RESPONSE TO COUNCIL RFI

Area 5

13-19 Canberra Avenue
St Leonards South NSW 2065

Prepared for
HYECORP

10D. CHILDCARE CENTRE PLAYGROUND AREA - AWNING

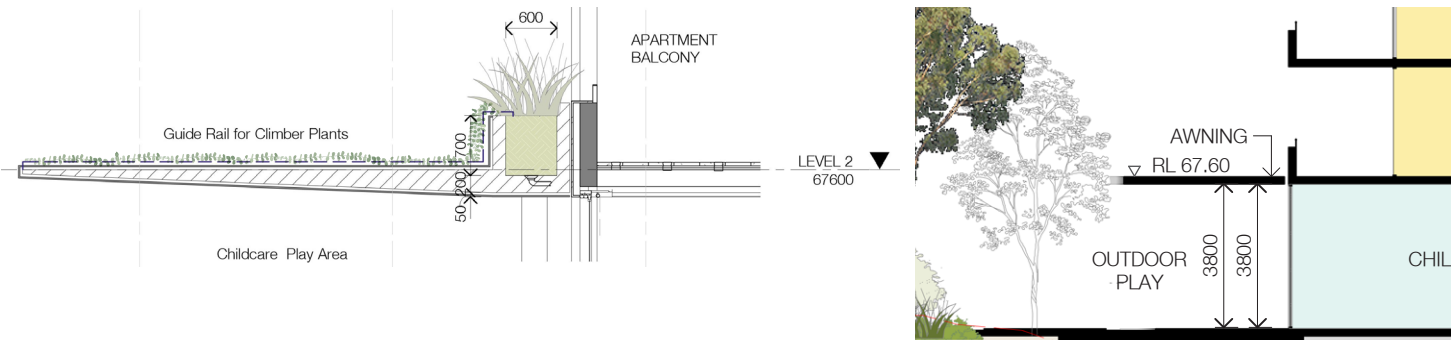
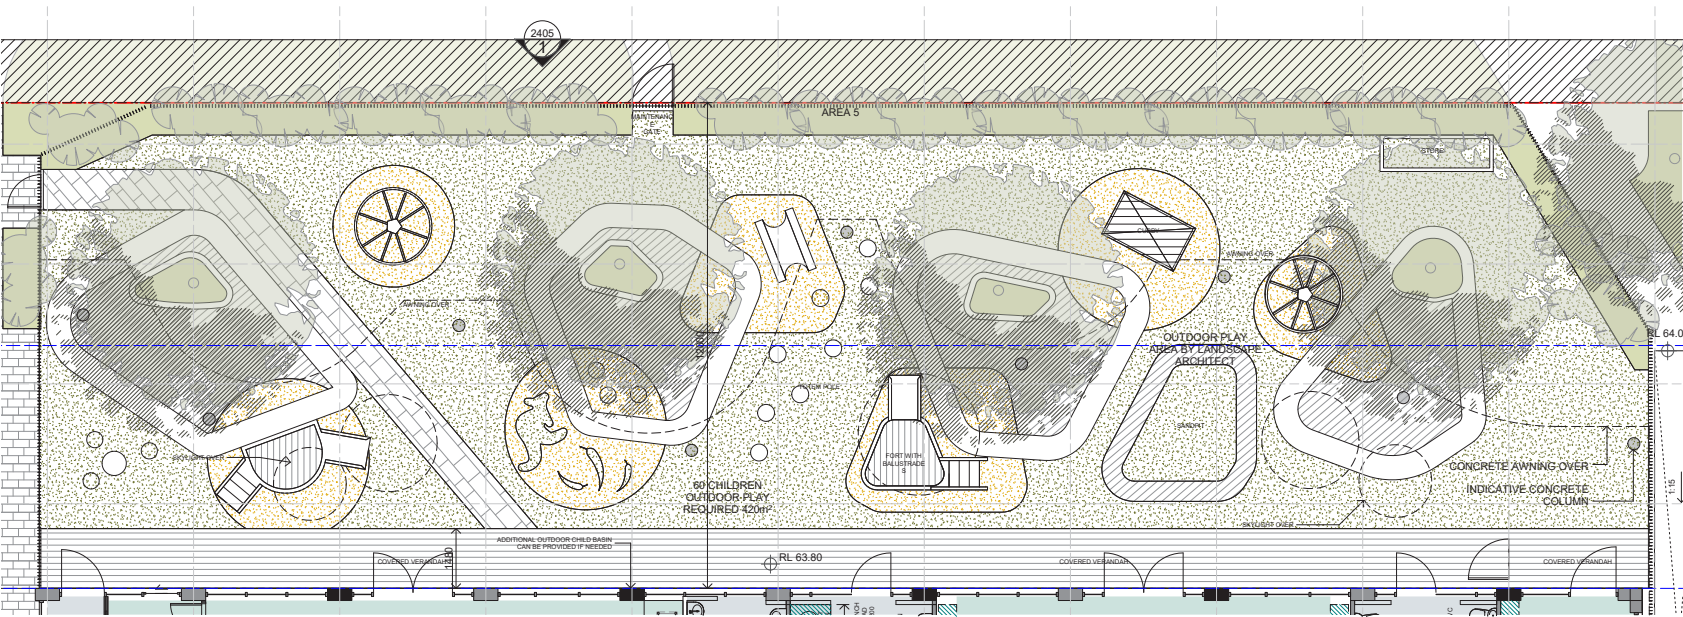
- Detail drawings should be provided for the proposed awning over the outdoor play space detailing its construction, materiality and proposed height.

1. The outdoor awning is made out of concrete with concrete planters along the edge of the building and skylights throughout. It will be supported on simple concrete columns. The details will be coordinated with the structural engineer and the landscape architect throughout the design development process. The proposed height is set to provide minimum visual distraction to the residence above while shielding the acoustics from the childcare center and providing sun protection for the users of the outdoor play area.

13. SEPP 65

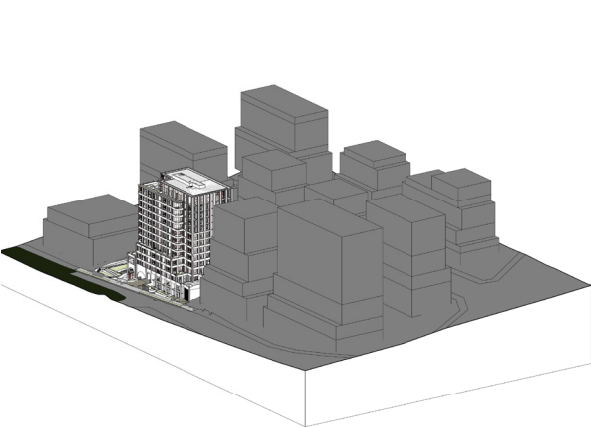
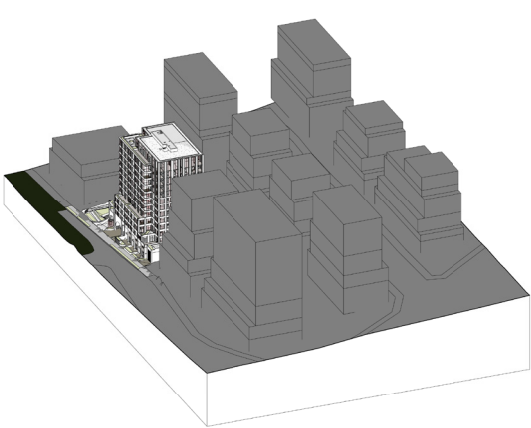
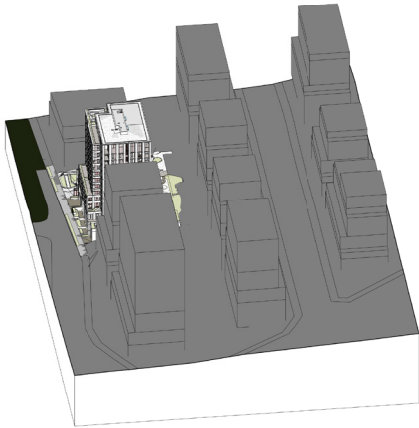
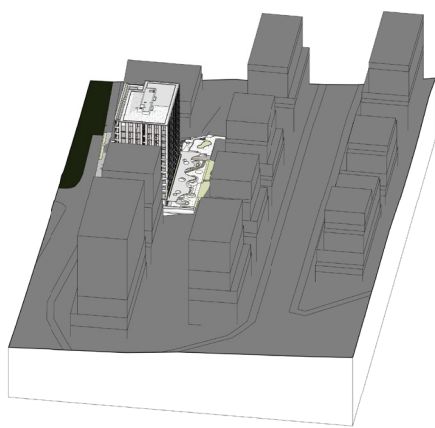
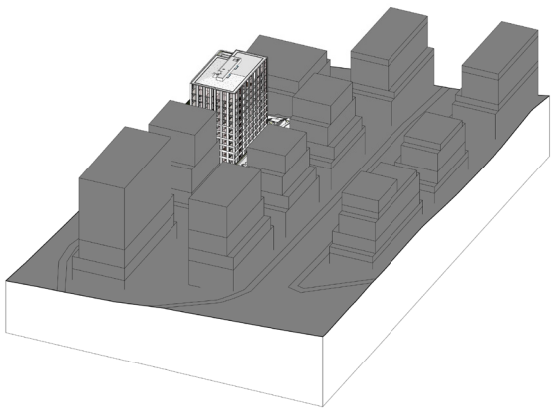
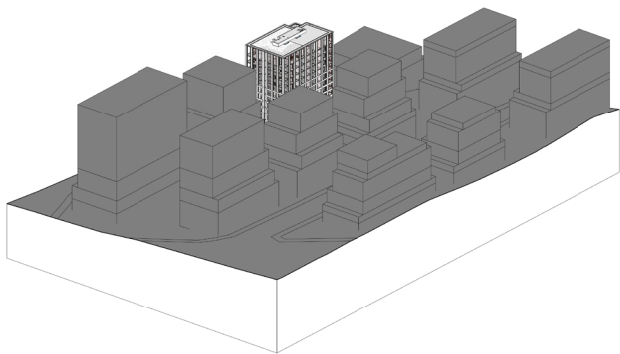
- Confirmation is required the solar access assessment incorporates overshadowing from future buildings within the St Leonards South Precinct.

1. The applicant confirms that the solar access assessment incorporates overshadowing from future buildings within the St Leonards South Precinct. The massing are derived from the masterplan framework.

i. BASEMENT ABOVE NGL

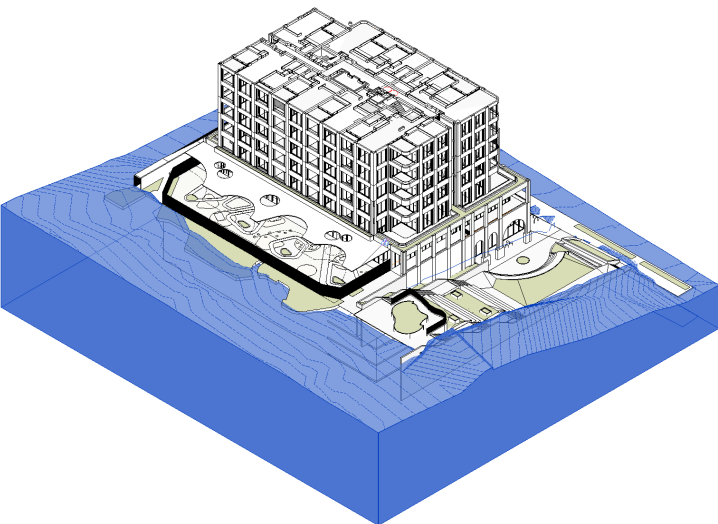
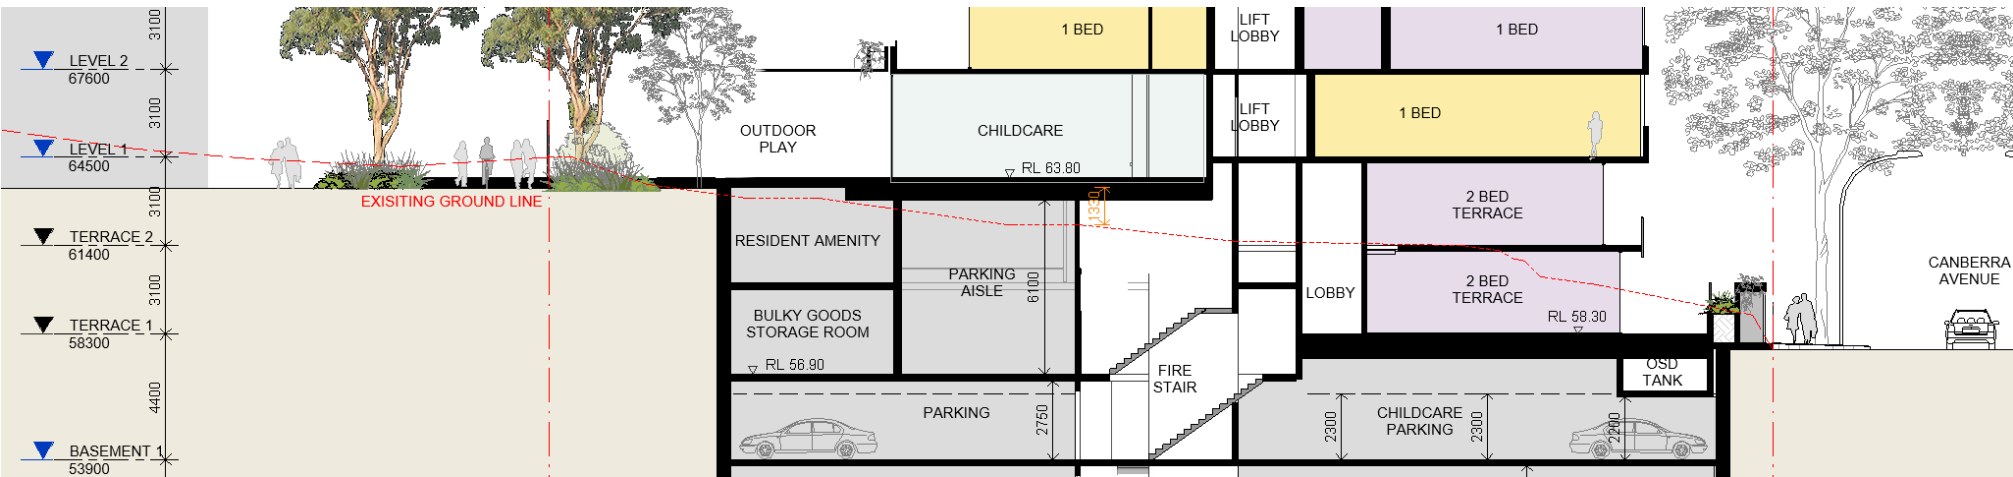
- The community has raised questions regarding the maximum 1.5m of basement being above the natural ground level

1. The proposed basement design is only above the NGL towards the western edge by approximately 1.35m at most and therefore complies with the control. This is due to the steep level change between Canberra Avenue to the east and Green Spine to the west.

ii. BUILDING LENGTH

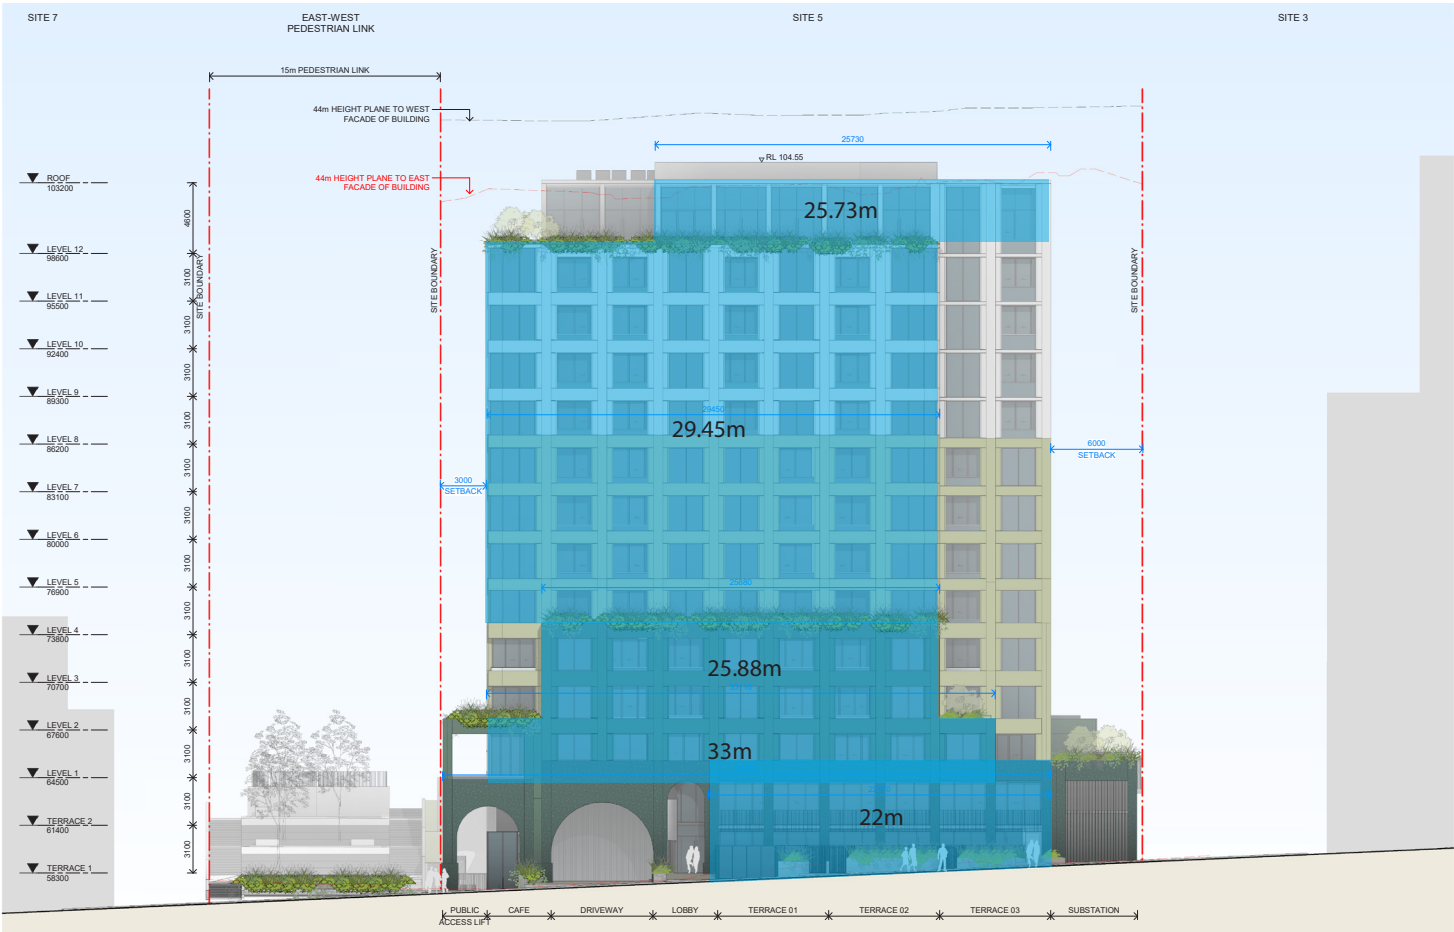
- The community has commented that the strong articulation dimensions stated in the DCP had not been provided for to allow a breach to the maximum building length requirement of 35m.

1. The DCP control provides that the maximum building length shall not be greater than 35m unless strongly articulated. The objective of the building width control in the DCP is to avoid large continuous building bulk and massing fronting the street. The proposed design has been developed through a comprehensive design review and excellence process in consultation with the panel and Council to ensure strong articulation and design character for the building is achieved. The proposed building design has stepped back the massing fronting Canberra Avenue to provide facade articulation, reduce building mass and therefore complies with the DCP objective. The only facade width exceeding 35m is on ground floor, however, ground floor has multiple large penetrations on the facade to enable the functionality of the building, including the void into the retail corner, the carpark entry and the lobby entry. Furthermore, the substation has been pushed back from the street. Therefore the effective continuous facade on ground floor facing Canberra Avenue is only 22m.

Listed are the continuous facade width on the East elevation throughout the tower.

- Tower - Level 12 - 25.73m
- Tower - Level 4 to 11 - 29.45m
- Podium - Level 2 & 3 - 25.88m
- Podium - Level 1 - 33m
- Podium - Ground Floor - 39.57m (effective continuous facade is 22m.)
